San José City Data Center (19-SPPE-04)

Data Response Set 1A (Response to Data Request 19)

Submitted to
California Energy Commission

Subject San José Data Center Cultural Resources Survey for Linear Corridors

Figure 4.
 Geology Within 1 Mile of the Project Site
 San José Data Center (SJC02)
 San José, California

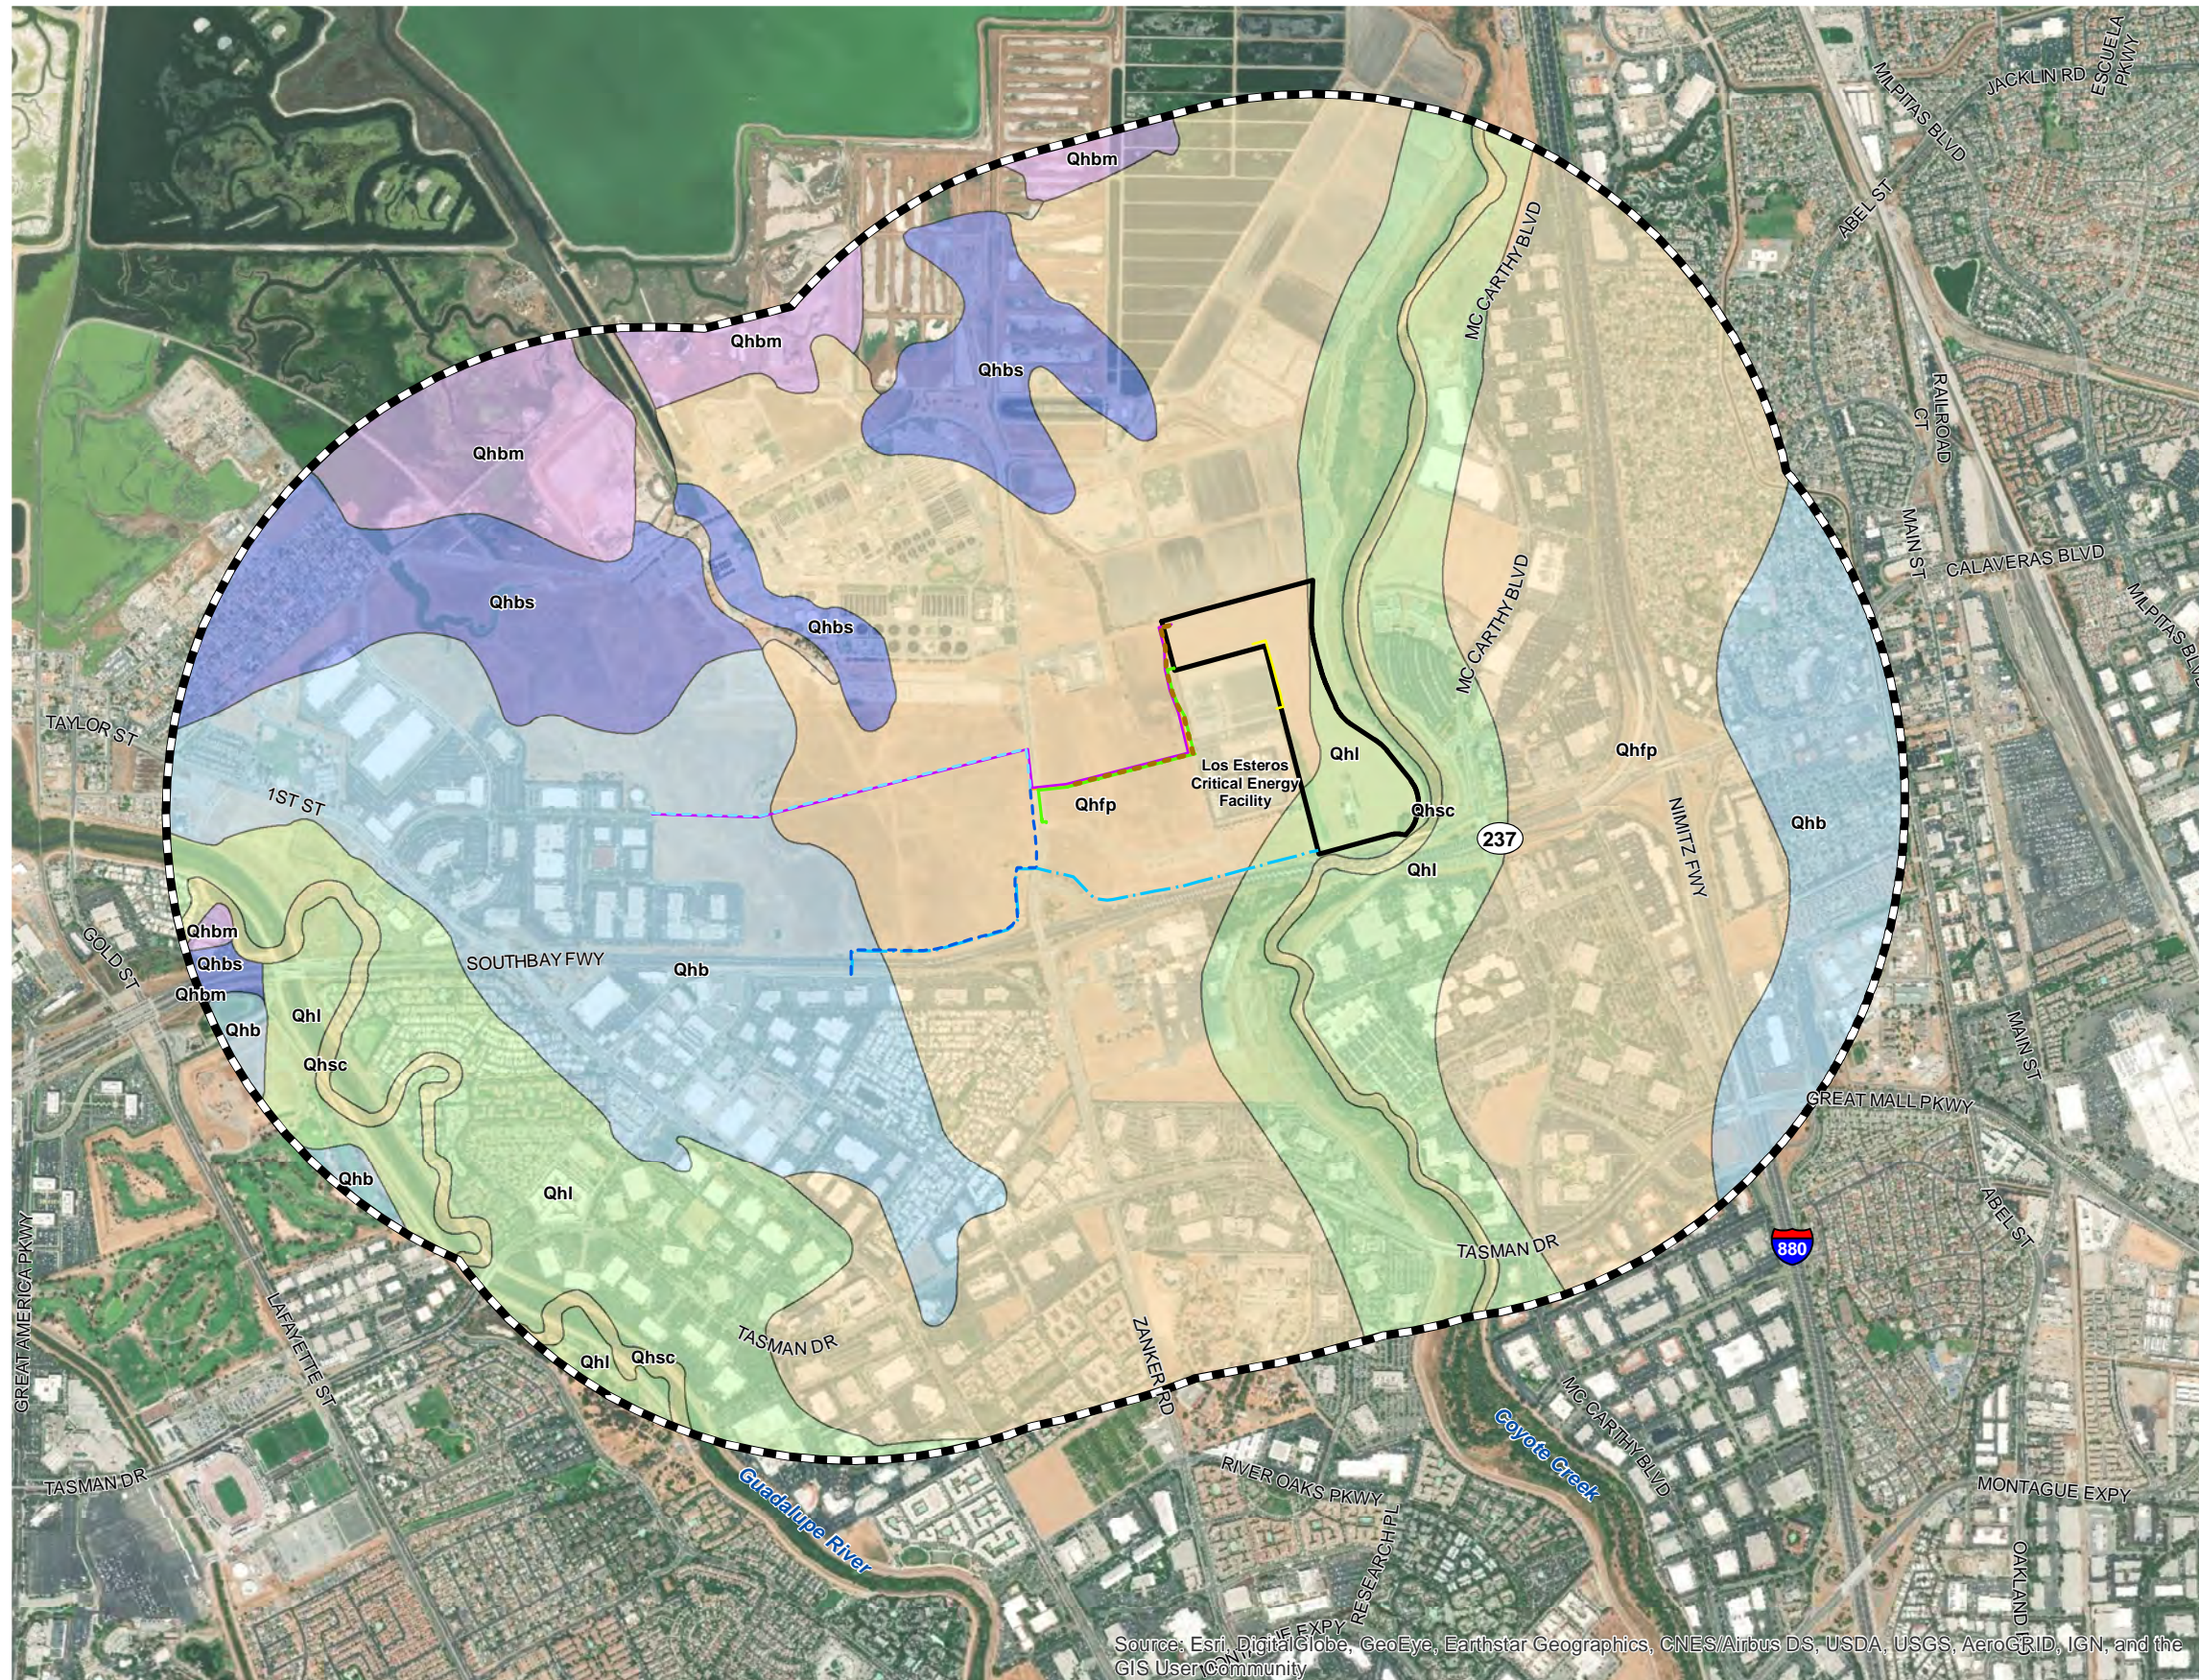
The geologic Map of Santa Clara County shows the area of the project contain such late Holocene natural levee and floodplain deposits (Qhfp and Qhl) (Helley and Westling 1989) (see Appendix Figure 4). The age and depositional nature of these deposits are such that the project site retains the potential for unknown, buried cultural resources despite previous ground-disturbing activities at the site.

Consistent with the applicants proposed design measure CUL-1.1, prior to the issuance of any grading permit, the project will be required to complete subsurface testing to determine the extent of possible resources onsite. Subsurface testing shall be completed by a qualified archaeologist. Based on the findings of the subsurface testing, an archaeological resources treatment plan shall be prepared by a qualified archaeologist and submitted to City of San José for approval prior to the issuance of grading permits.
